MODELS: 33, 38

GASKET FOR THE TANK

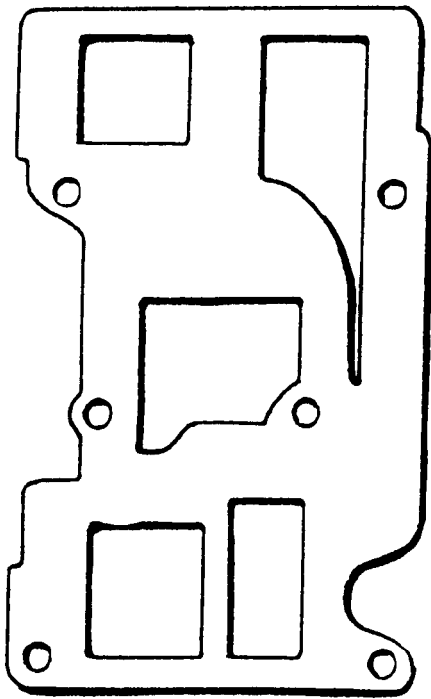
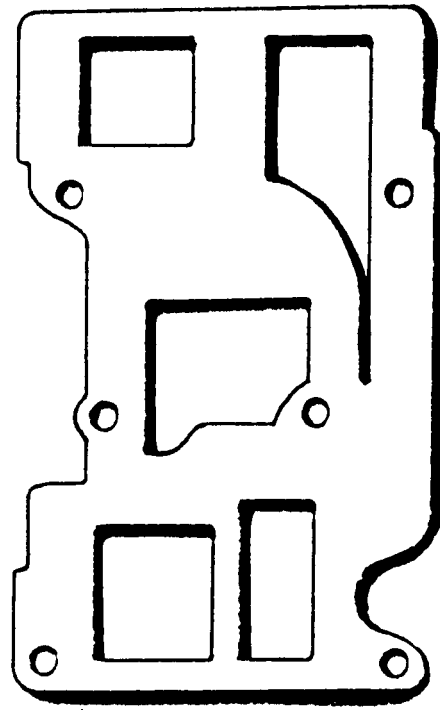
The gasket between the front and rear tank halves have been changed concerning material and thickness. The gasket keeps the old Ref. No. 507 43 33-73, despite the change. The change of material means a higher mechanical strength and increased shape stability. The thickness is changed to 2,5 mm/0,093" compared to previous 1,7 mm/0,062".

The change is introduced from serial number 913652498.

↑
1,7 mm/0,062 inch
Previous design

↑
2,5 mm/0,093 inch
New design
